**SUPPLEMENT TO WORK PLAN ADDENDUM  
OPERABLE UNIT 5 OUTFALL LINE  
INVESTIGATION GROUNDWATER SAMPLING  
PROGRAM FINAL U.S. EPA AND OHIO EPA  
COMMENT RESOLUTION NOVEMBER 1993**

FERNALD ENVIRONMENTAL MANAGEMENT PROJECT  
FERNALD, OHIO  
REMEDIAL INVESTIGATION AND FEASIBILITY STUDY

U.S. DEPARTMENT OF ENERGY  
FERNALD FIELD OFFICE

FIGURE 2

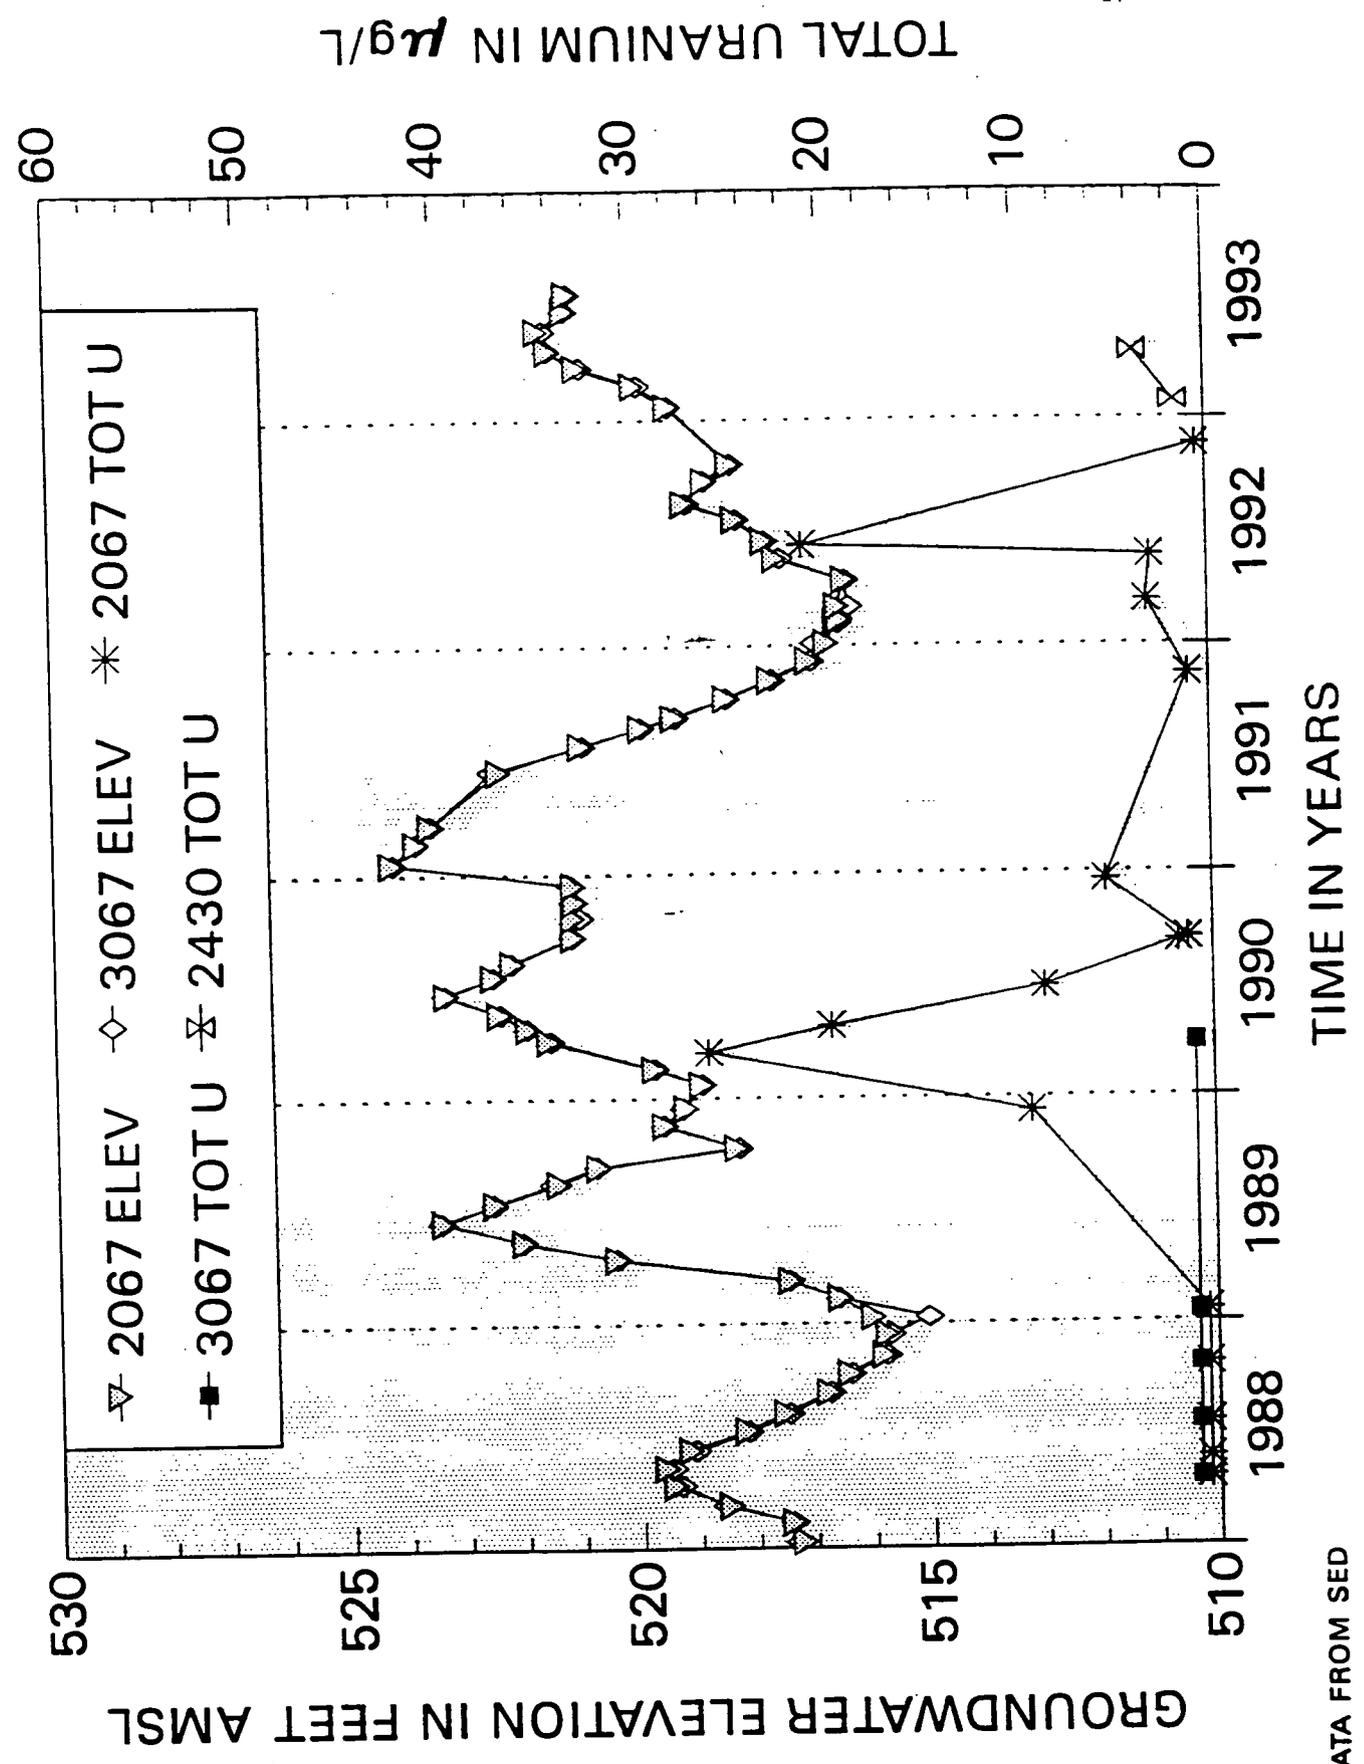
- 2. Section 2.0, Page 2, Paragraph 2. DOE correlates the elevation of the Outfall Line with the Great Miami River. The purpose of this discussion is to identify potential factors contributing to failure of the Outfall Line. Although this may be important, DOE should also discuss the relative elevation of ground water to the base elevation of the Outfall Line. This information is critical in evaluating the migration pathway to ground water from the Outfall Line.

2091, 2097 and 2098. Average yearly groundwater elevations in those wells range from 512 to 521 feet above mean sea level (MSL). In addition, the average water level measured in Monitoring Well 2119 since February 1993 is 520 feet above MSL. The bottom depth measurements of the pipeline at Manhole 179 and Manhole 180 are 564 feet 530 above MSL respectively and the pipeline elevation decreases slightly between Manhole 180 and the river. Comparing the elevation of the pipe at Manhole 180 and the water table at Well 2119, it is evident that the pipe is approximately 10 feet above the average water table at that location.

FIGURE 1

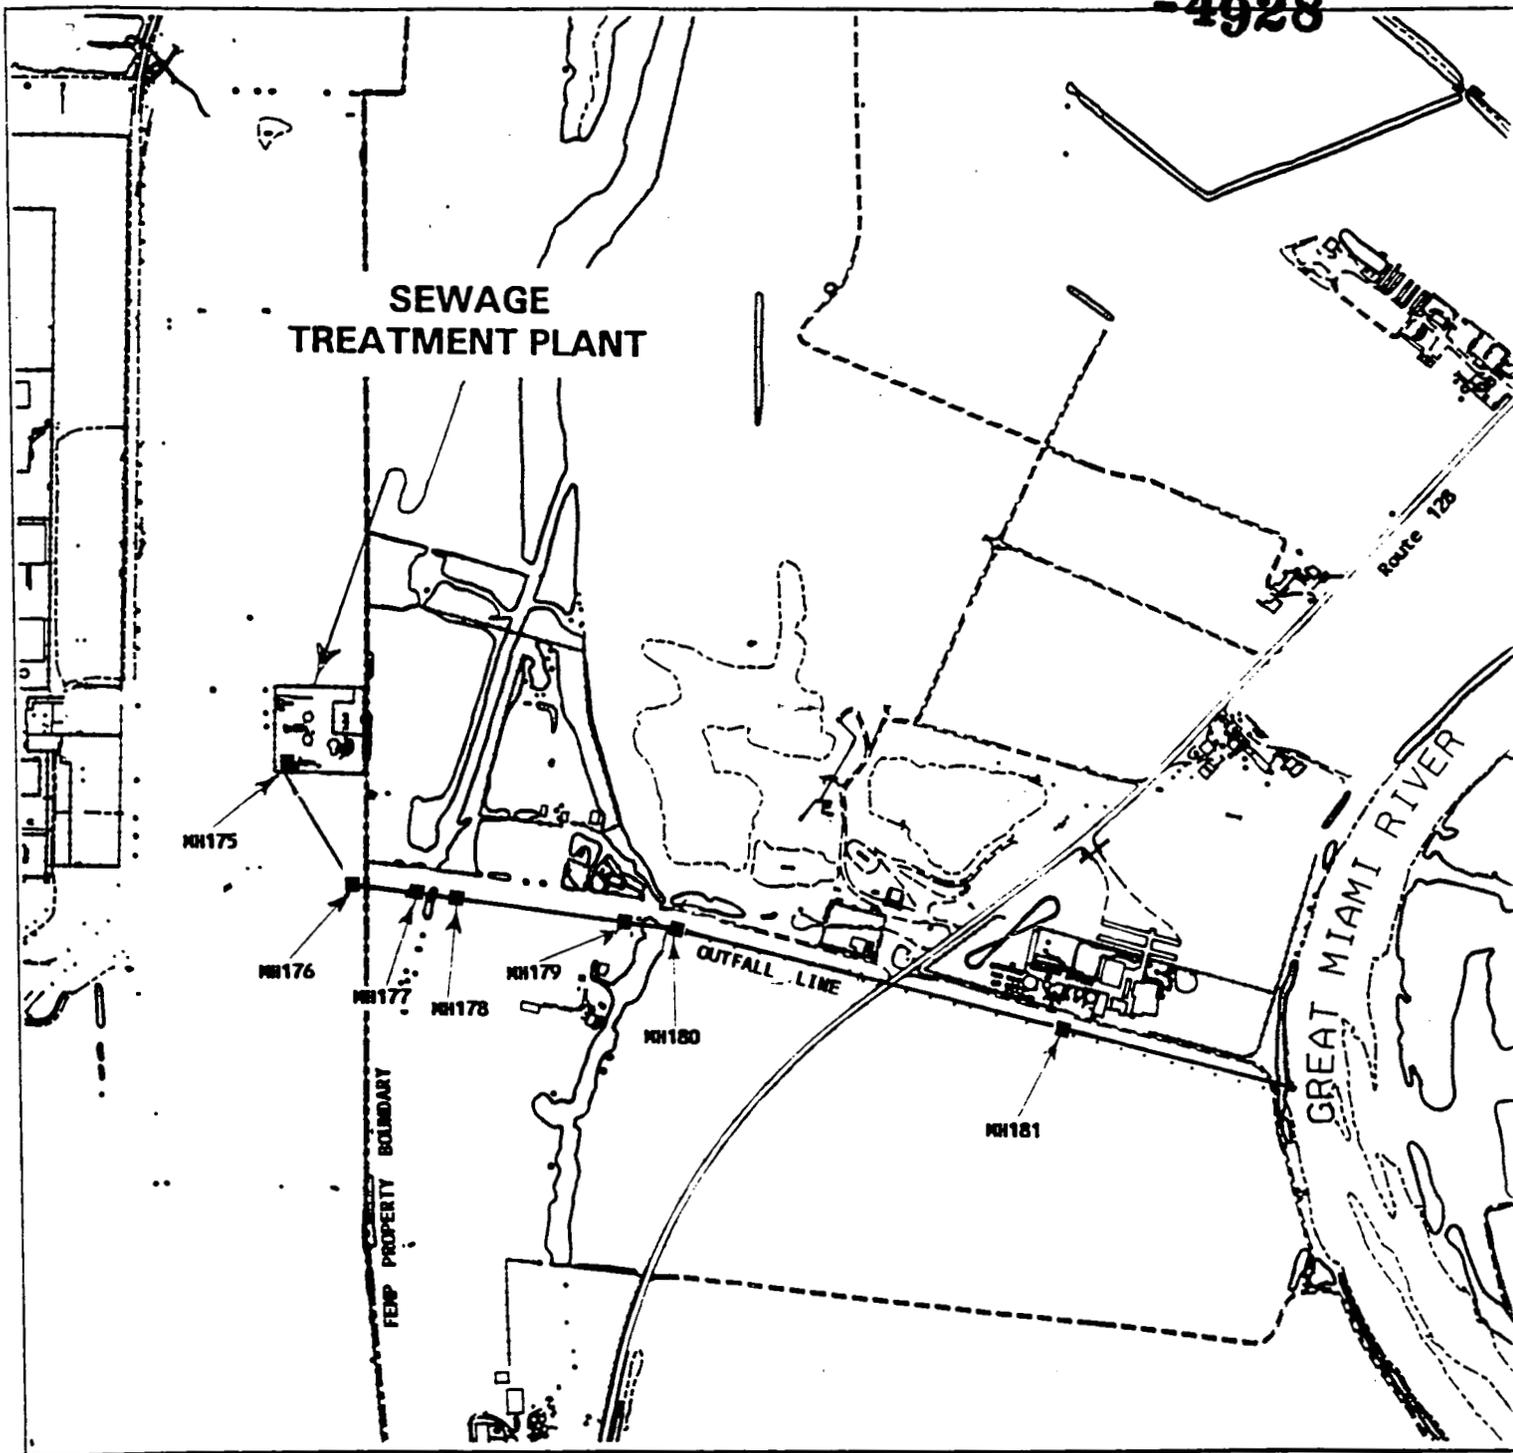
Comment: Figure 1. The figure is hard to read and should be larger providing more detail as to the location of the STP and any additional monitoring wells.

1. Figure 1: The figure is hard to read and should be larger providing more detail as to the location of the STP and any additional monitoring wells.
2. Page 1, Paragraph 2: It should be more appropriate for DOE to assign the value of .5 ppb to the BDL's instead of 0.

Resolution: DOE agrees with the comment. Figure 1 is revised to provide additional detail illustrating the position of the Sewage Treatment Plant and the Outfall Line. Figure 3 is revised to illustrate locations of all monitoring wells pertinent to the assessment of the Outfall Line. Amendment OSTC-1 presents revised Figure 1; Amendment OSTC-9 presents revised Figure 3.

**TOTAL URANIUM IN HYDROPUNCH SAMPLES  
COLLECTED FROM MONITORING WELL 2119**

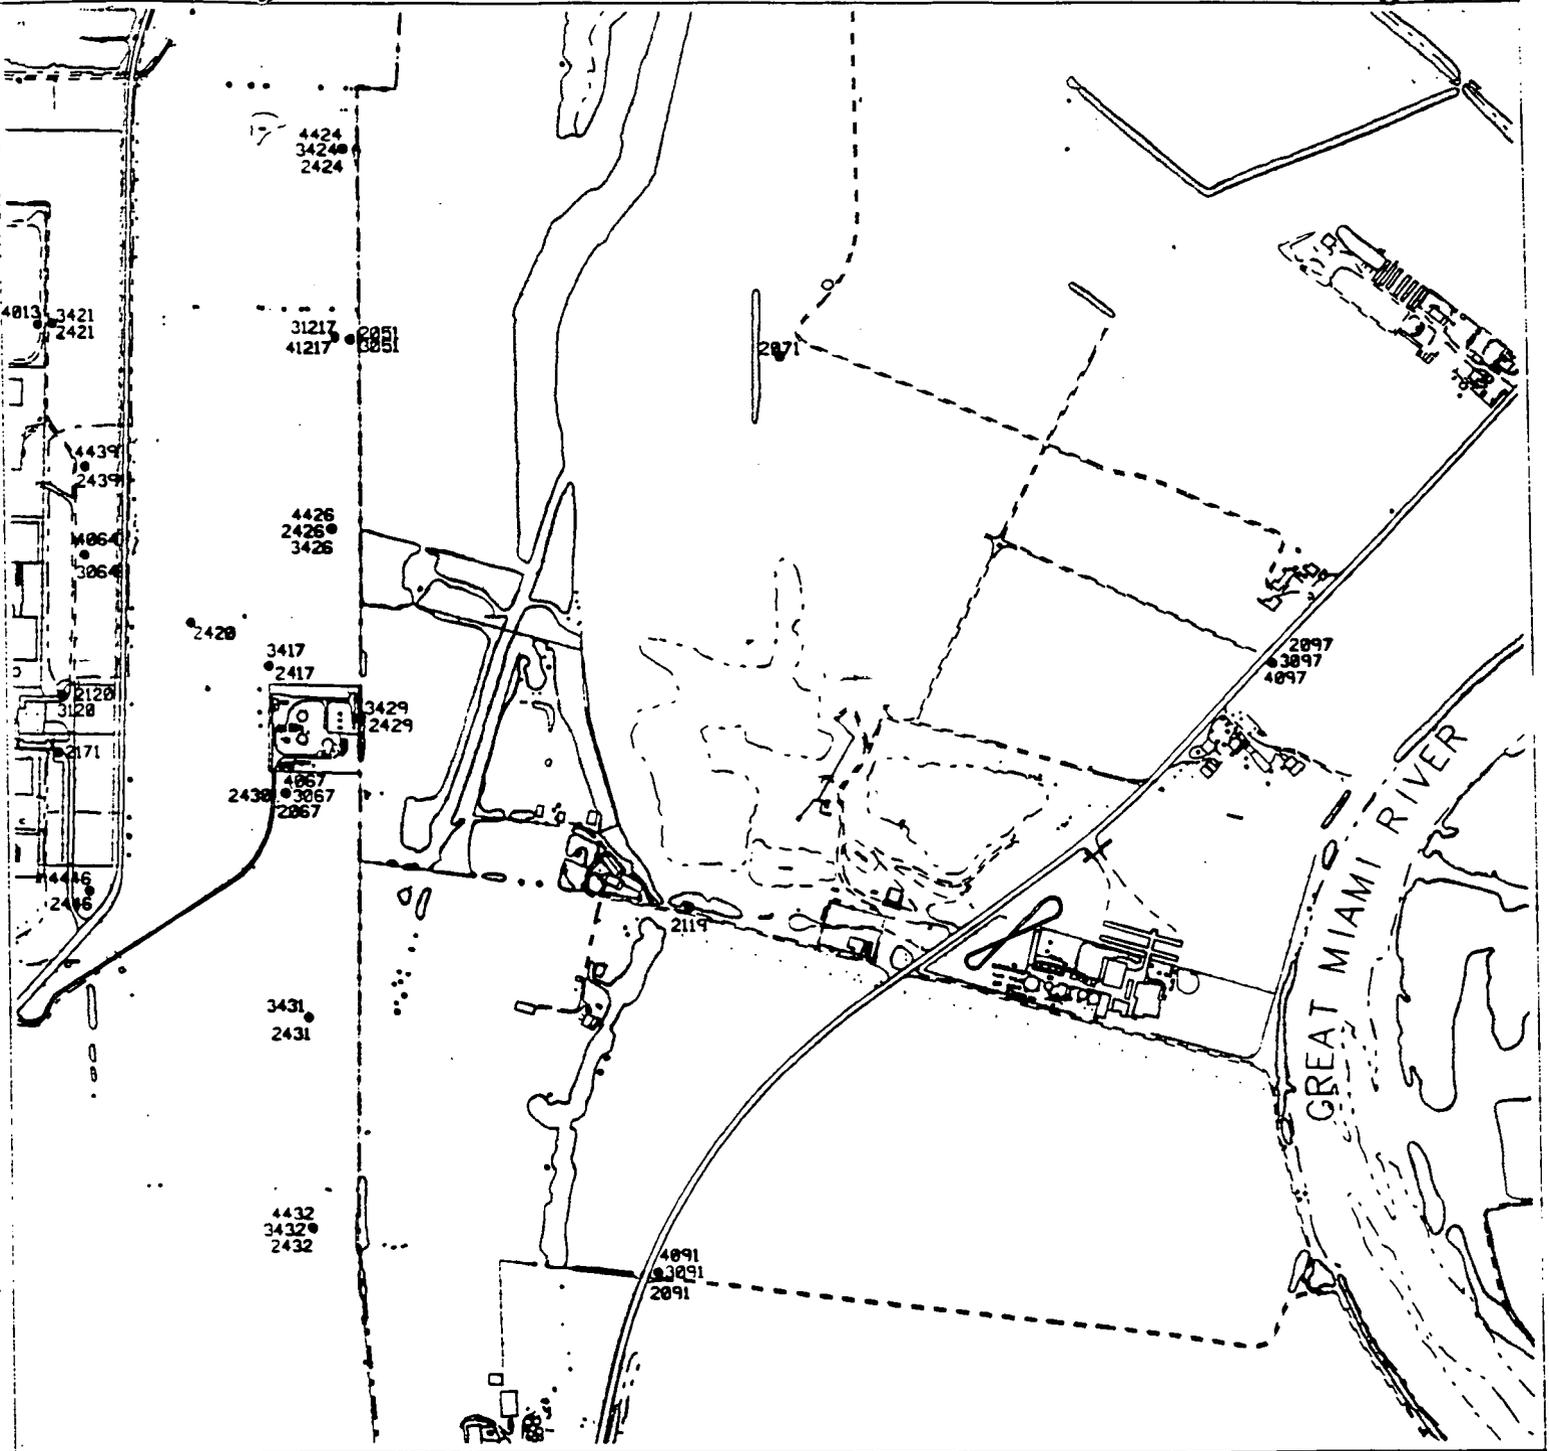
7. Section 4.1: a) DOE should discuss the expected total depth of the boring and the expected depth of the monitoring well screen. b) DOE should expand the scope of hydropunching to determine the areal extent of contamination.

hydropunch samples collected were all at background levels. Amendment OSTC-7 presents a table of total uranium concentrations detected in the Hydropunch samples. Since the Hydropunch samples did not detect any evidence of a plume, the well was installed as a standard 2000-series well. Ten of the 15 feet of screen extend below the water table.
